SUBJECT: W.P. 37-66-07, Site 31-294,  
 C.N.R. Overhead (H. B. L. & W. B. L. Structures),  
 (2.6 Miles East of Highway 34 Interchange),  
 Highway 417, District 9 - Ottawa

The Proposed Overhead Structures at  
The Crossing of Hwy. #417 (Eastbound  
And Westbound Lanes) and the C.N.R.  
Twp. of Lochiel, County of Glengarry  
District No. 9 (Ottawa)

FOUNDATION INVESTIGATION REPORT

The following are Road Design comments regarding Preliminary Plans D-6932-PI and D-6966-PI.

SUB-EXCAVATION OF SOFT CLAY STRATUM  
HIGHWAY 417-W.B.L. OVER C.N.R. & TWP. ROAD

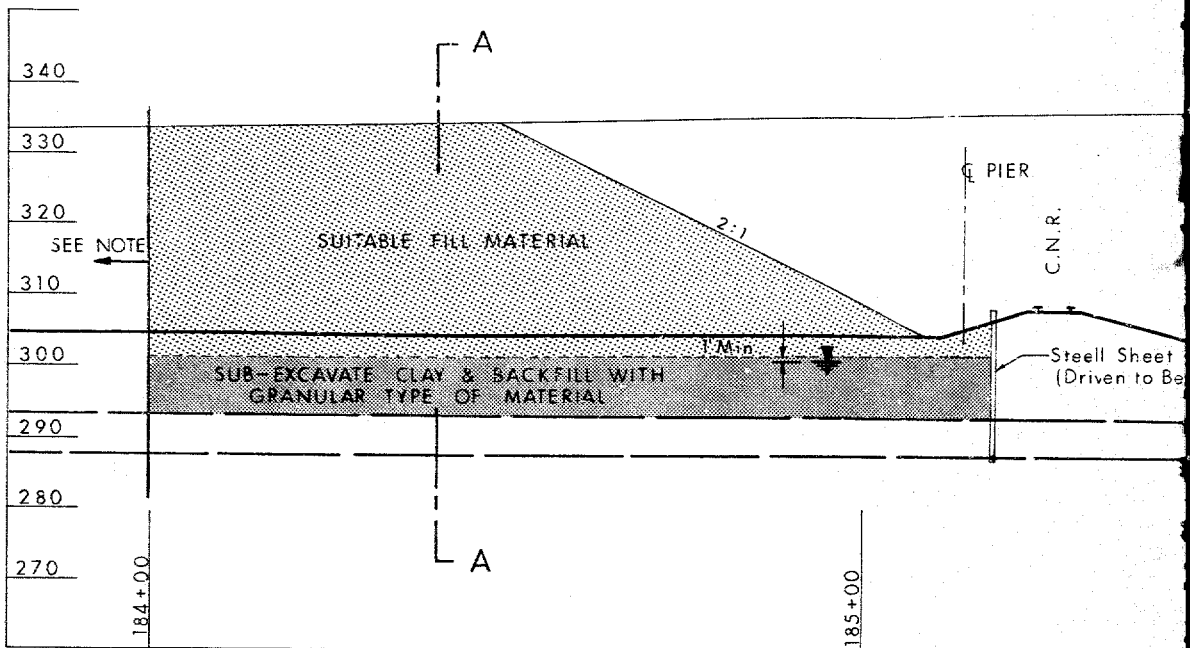
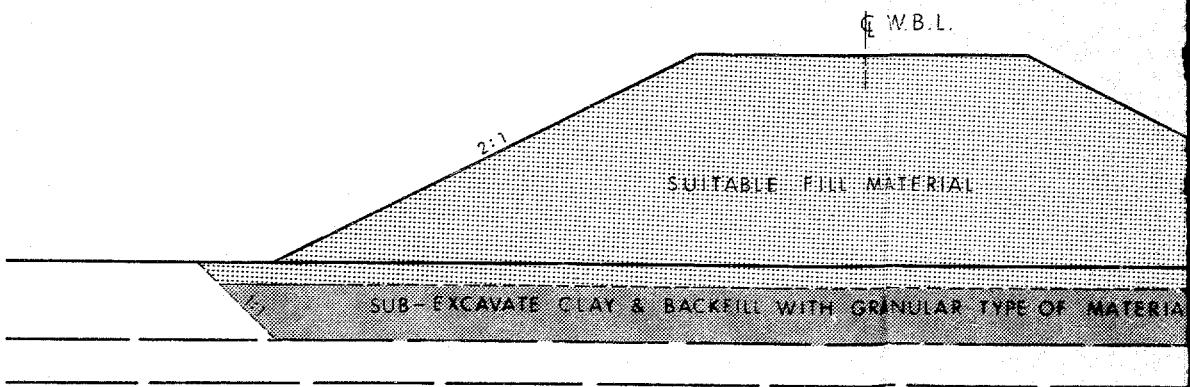
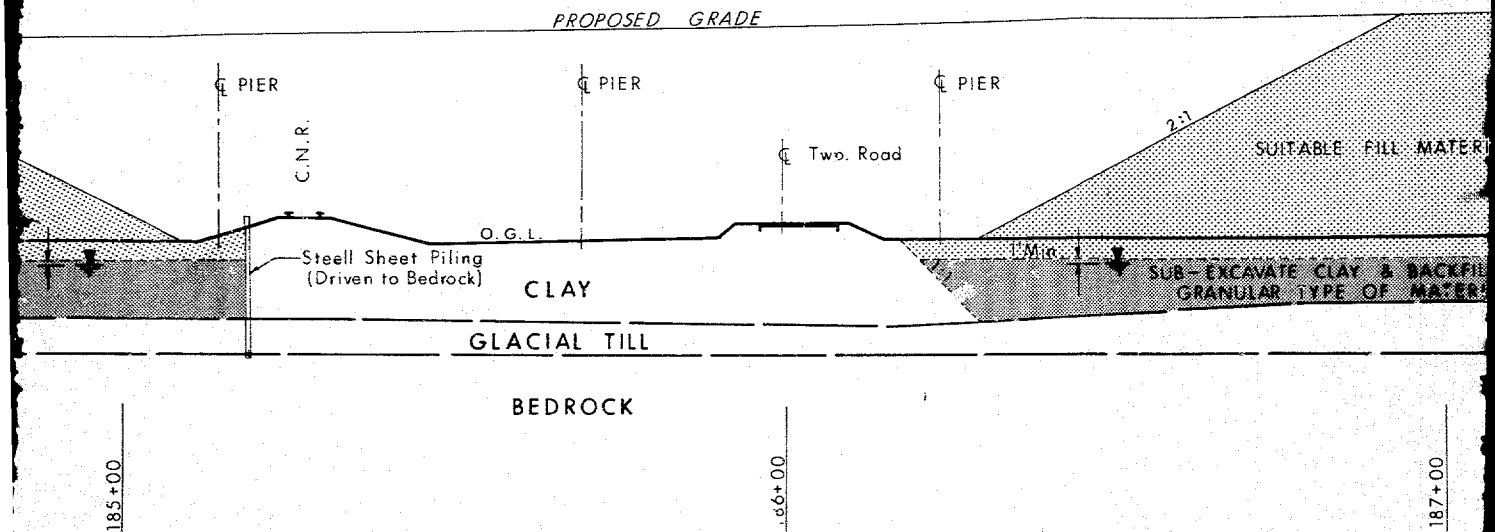
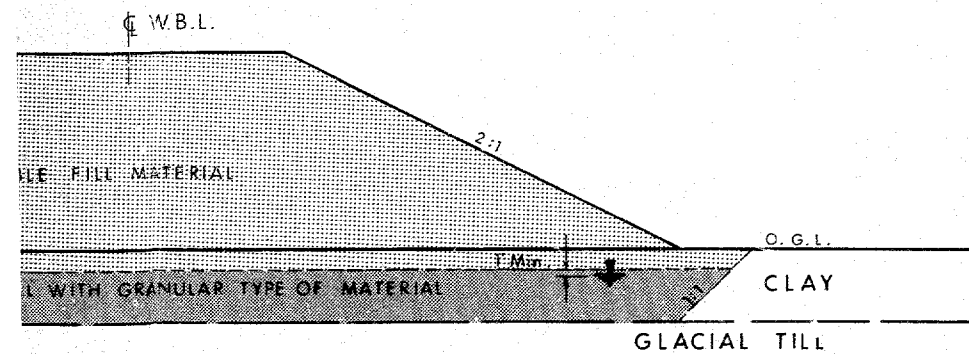
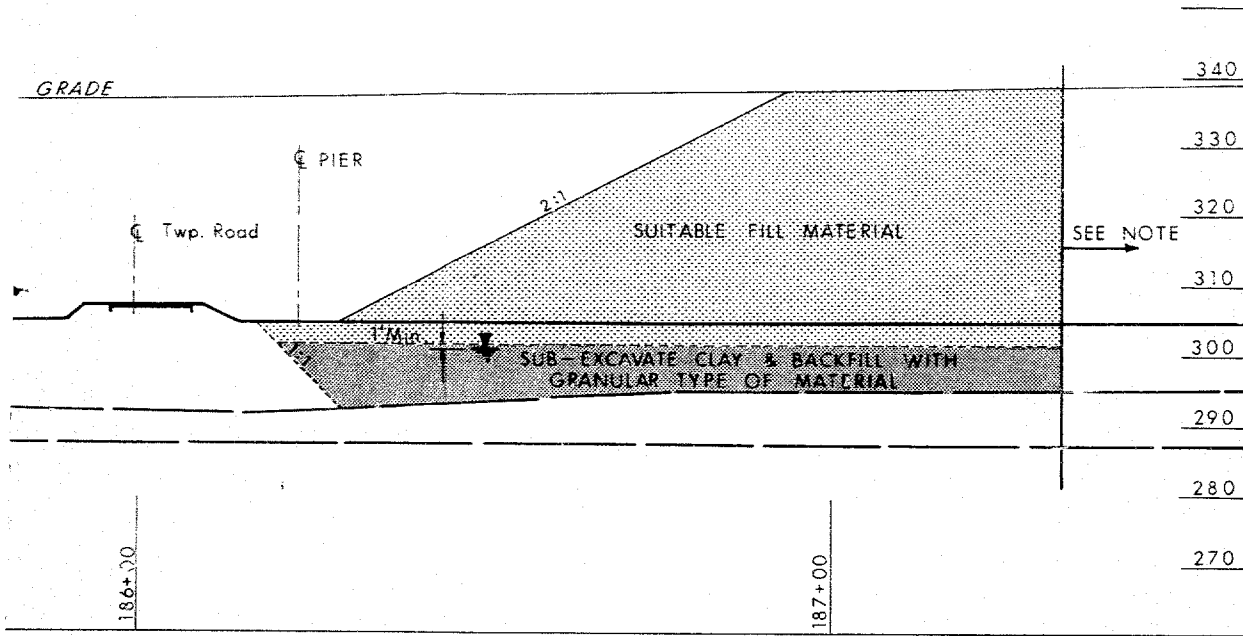
4. Additional information is still required from the Foundation Section to determine the extent of sub-excavation under the approach fills.
5. Does the revised slope of 1 3/4:1 on the westerly approach fill eliminate the need for steel sheet piling adjacent to the C.N.R. tracks as recommended by the Foundation Section. (See Figure 2 W.P. 37-66-07).

As can be seen from the sketch, excavating within the plan limits of the embankment and back at a 1:1 slope would place the top of the excavation unacceptably close to the tracks and the township road. Figure 2 of the Foundation Report recommends the use of steel sheet piling to support the railway embankment, however, it is questionable whether the thin layer of glacial till is sufficient to support the piling. It has been suggested that a second set of piles be driven on the other side of the tracks and the first set tied back to them. Another alternative would be to drive a set of piles on the same side of the tracks as the first set and place struts between them.

3. The note on the drawings regarding granular materials will be changed to "granular type materials", if it is left on the bridge drawings at all.
4. Foundation Section have now issued an addendum dated March 1st, 1971 to their original foundation report for this site. The addendum establishes the plan limits for sub-excavation at the approach fills for the W.B.L. structure.

*Discussed with Mr. E. McMillan on telephone and concluded that railway ~~part~~ portion will be shown on the drawing, without specifying any method of construction.*
